TECHNICAL NOTE

Subject: **Response to DPHI on Keri Keri PHA RFI (J-000887-TN-01-Rev 0)**

Figure 1: Amended Project Layout of Keri Keri Wind Farm

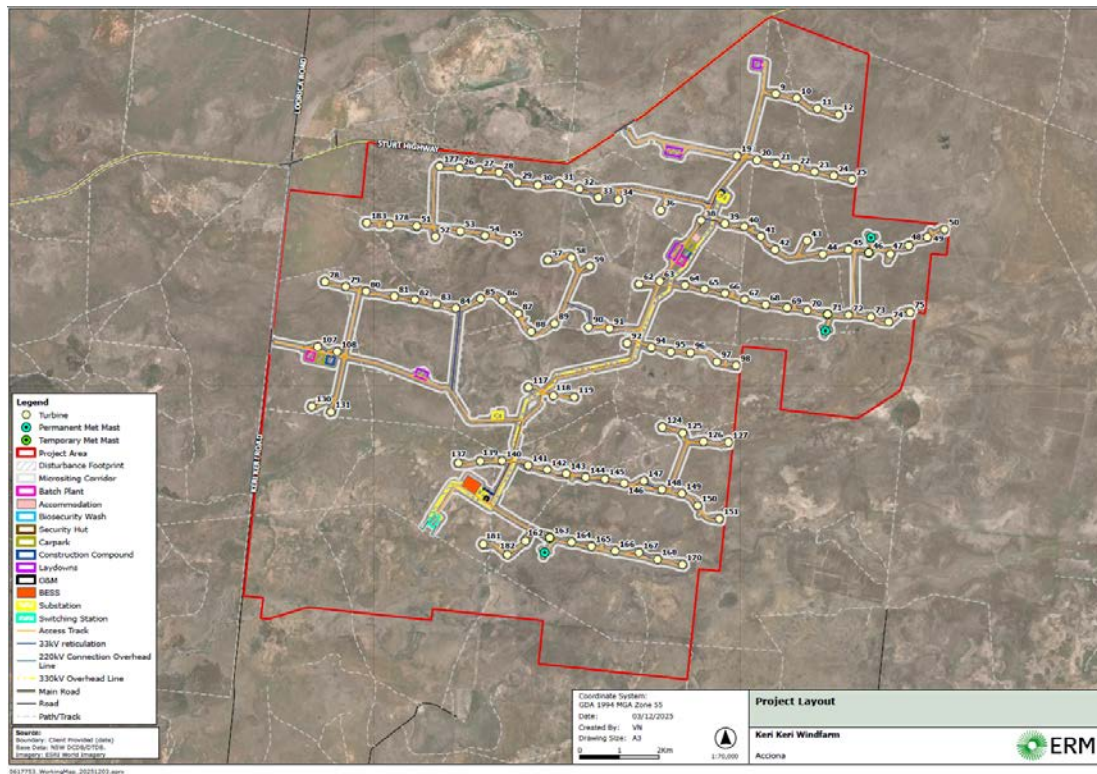
The previous risk analysis in the PHA [1] found that WTGs 26, 27, 177, 186 and 187 contribute to the risk at the Willowvale rest area. As per the amended project layout of the Keri Keri wind farm shown in Figure 1, WTGs 186 and 187 have been removed.

Based on the amended project layout in Figure 1, the risk at the rest area was recalculated and the updated risk contours are shown in Figure 2. The rest area remained encroached by the 10 pmpy contour. It was found that the principal contributor to blade throw risk to Willowvale rest area is WTG 177.

Figure 2: Updated LSIR Contours for Amended project Layout

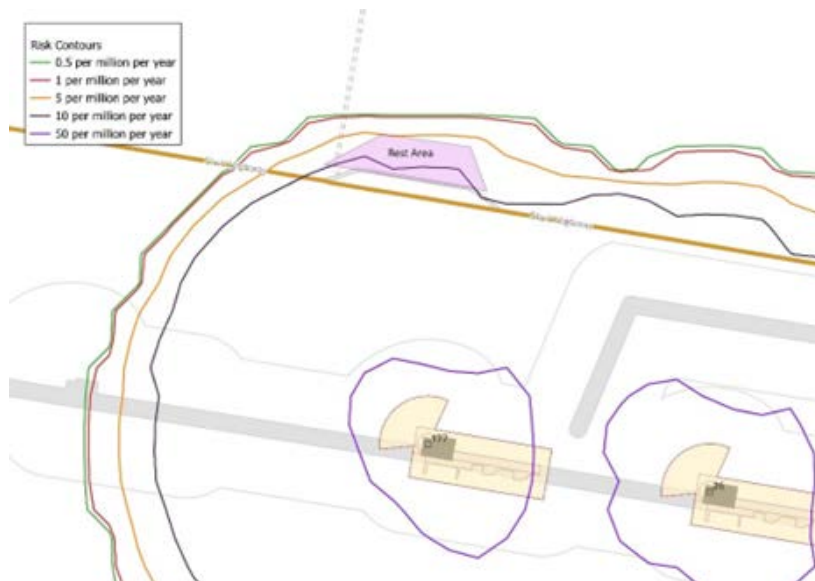
- From the projectile throw risk assessment in PHA Section 5.2.4 and Figure 29, it is understood that the HIPAP 4 location specific individual risk criteria (LSIR) for 'active open space' (10 pmpy) is exceeded at the rest area along the Sturt Highway. From PHA Figure 29, it appears that the cumulative risk at the rest area was based on risks originating from Turbines 166, 177 and 26. However, PHA Figure 2 and the detailed maps in EIS Appendix F only shows Turbines 177 and 26 without showing Turbine 166. As such:*

- Confirm if Turbine 166 will be installed as part of the SSD. If not, reassess the risk based on the finalised location of turbines (PHA Figure 2, EIS Appendix F or otherwise) and confirm if the LSIR criteria for 'active open space' (10 pmpy) is still exceeded at the rest stop.*

Figure 4 Comparison of the 10 pmpy LSIR Contours

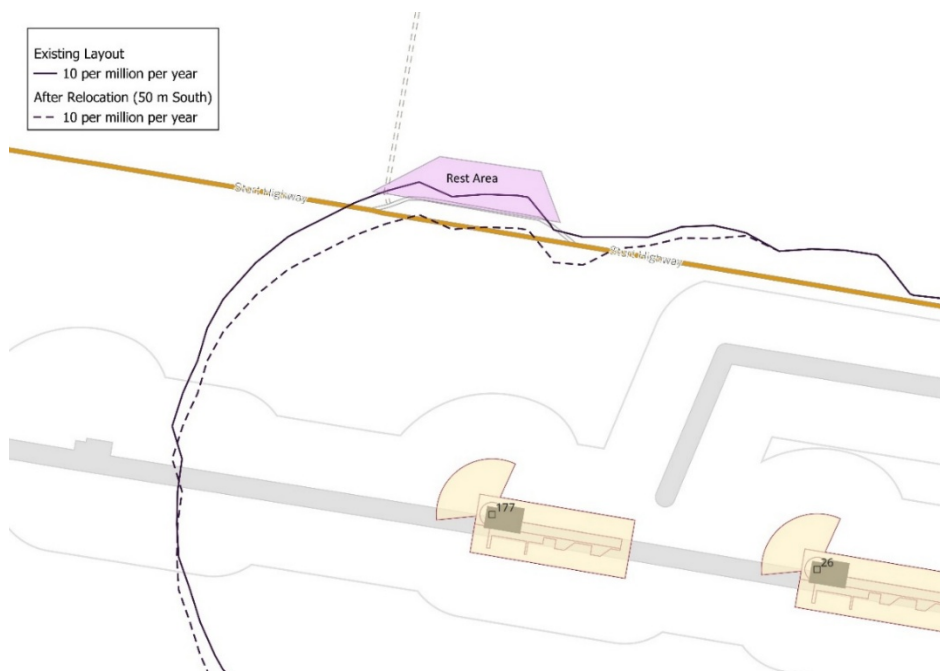
- If Turbine 166 is confirmed to be installed as part of the SSD or if the LSIR criteria for 'active open space' (10 pmpy) is still exceeded at the rest stop despite the removal of Turbine 166, provide further recommendations on how the risk at the rest stop can be minimised (turbine repositioning, slew/rotation restrictions, smaller turbines, etc.)."*

Since WTG 177 was the largest contributor to risk at Willowvale rest area, a sensitivity analysis was carried out by relocating WTG 177 at distance of 50 m to the south of the current proposed location. The revised risk contour is shown in Figure 3.

It is seen that the 10 pmpy contour falls outside the Willowvale rest area, satisfying the HIPAP 4 risk criteria.

A comparison of the risks for the amended project layout and for the layout with relocated WTG 177 is shown in Figure 4.
